UNITED STATES PATENT AND TRADEMARK OFFICE

APPLICATION NO.	FILING DATE	FIRST NAMED INVENTOR	ATTORNEY DOCKET NO.	CONFIRMATION NO.
09/476,521	01/03/2000	Herbert Gropp	RUM212	7964

Office Action Summary

17. Claims 1-7 and 9-16, as best understood, are rejected under 35 U.S.C. 102(a) as anticipated by or, in the alternative, under 35 U.S.C. 103(a) as obvious over Seim *et al.* (Publication “*Erhöhung der Sicherheit gebauter . . .*” cited in EPO Search Report in the parent application).

Fig. 1

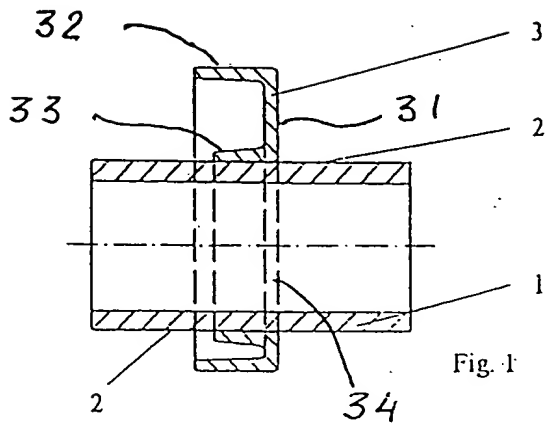
(C) The corrected Fig. 1 has been approved.

(a) the drawings should show the plane upon which a sectional view such as Fig. 1 is taken; and

Fig. 2

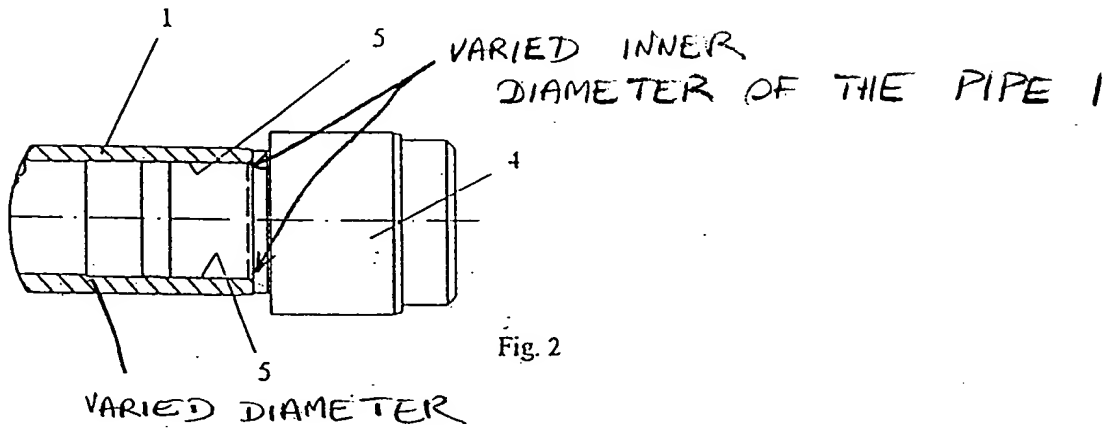
(a) new Fig. 4 introduces new matter such as the end piece 4 as now shown. The original Fig. 2 shows that the inner diameter of the pipe 1 is varied: (1) at the junction of the end piece 4 and the pipe 1 as shown by applicant's phantom line; and (2) at referential numeral 1 (see attached Exhibit). However, Fig. 4 shows that the inner diameter of the pipe 1 is constant. The

Not
Approved
VL
10/20/00

Fig. 3

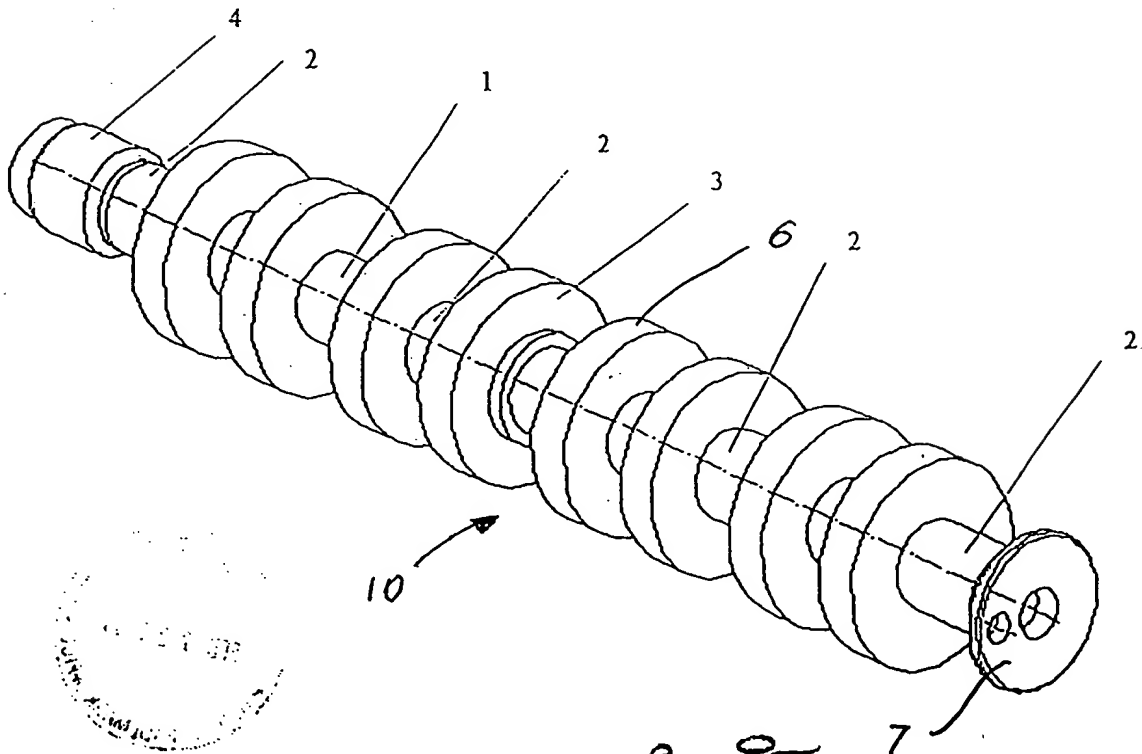
(B) The corrected Fig. 3 has been disapproved since it introduces new matter. The original drawings do not show the bearing rings. The corrected Fig. 3 now shows the bearing 6 which is identical to the cam 3. The showing and description of a specific type of bearing within a full spectrum of possible bearings is considered under the present disclosure to be new matter. *Cf., In re Smith*, 173 USPQ 679 (CCPA 1972) and *Ex parte George*, 230 USPQ 575, 578 (BPAI 1986).

(b) the orientation of the cams 3 as now shown in Figs. 11 and 18 is unsupported by the record as filed. In fact, the original Fig. 3 shows that the cams 3 are oriented in the same direction. However, new Figs. 11 and 18 show that the cams 3 are oriented in different directions (some are pointed to the left and some are pointed to the right). The different orientations of the cams 3 introduce new matter; and

(C) the insertions in lines 13 and 14 on page 6 of the specification. The original drawings do not show the bearing rings. The corrected Fig. 3 now shows the bearing 6 which is identical to the cam 3. The showing and description of a specific type of bearing within a full spectrum of possible bearings is considered under the present disclosure to be new matter. *Cf., In re Smith*, 173 USPQ 679 (CCPA 1972) and *Ex parte George*, 230 USPQ 575, 578 (BPAI 1986).

EXHIBIT
(PAGE 2 OF 2)

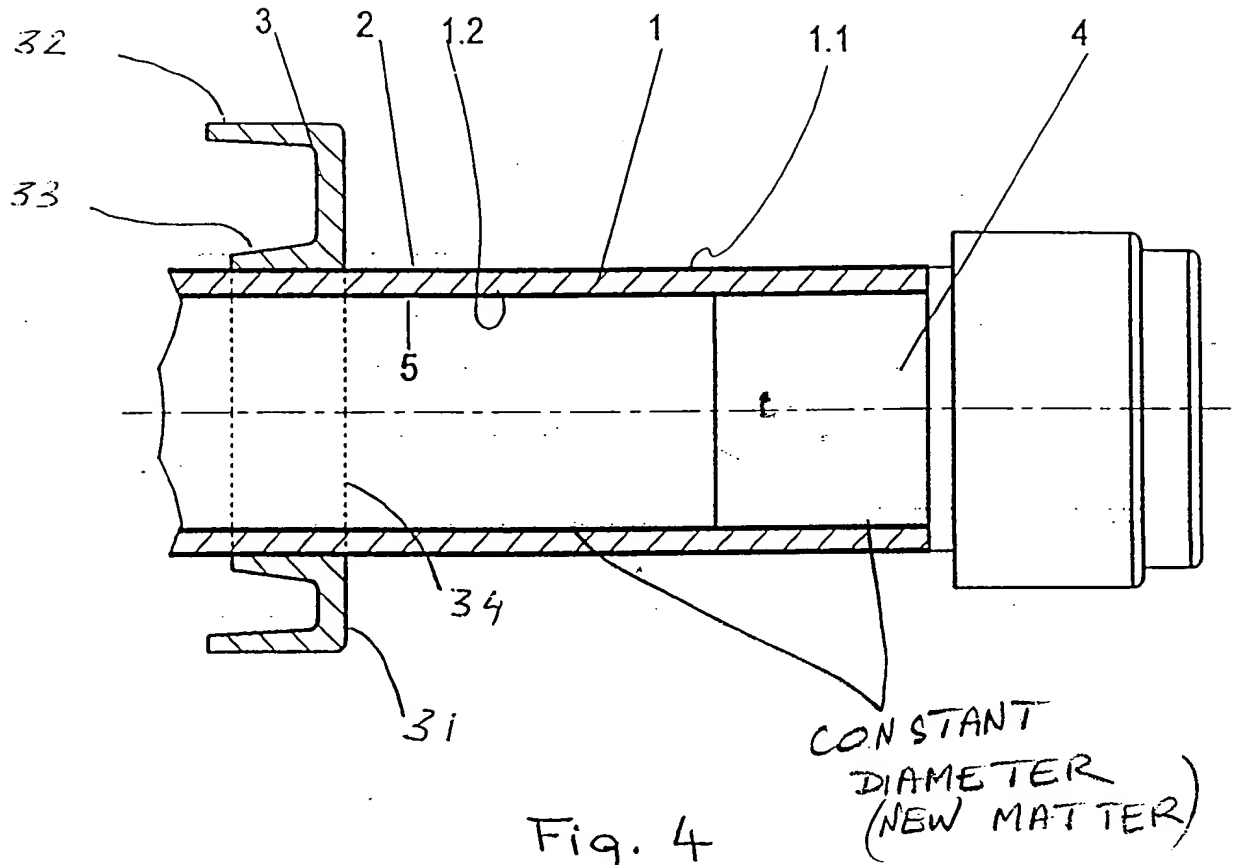
(A) New Fig. 4 has been disapproved because:

(b) new Fig. 4 is inconsistent with the description in Paper No. 9. The insertion on page 6, line 12 of the specification, states that the outer diameter of the end piece 4 is slightly larger than an inner diameter of the pipe 1. However, Fig. 4 shows that the outer diameter of the end piece 4 is equal to the inner diameter of the pipe 1.

Disapproved
VL
10/20/00
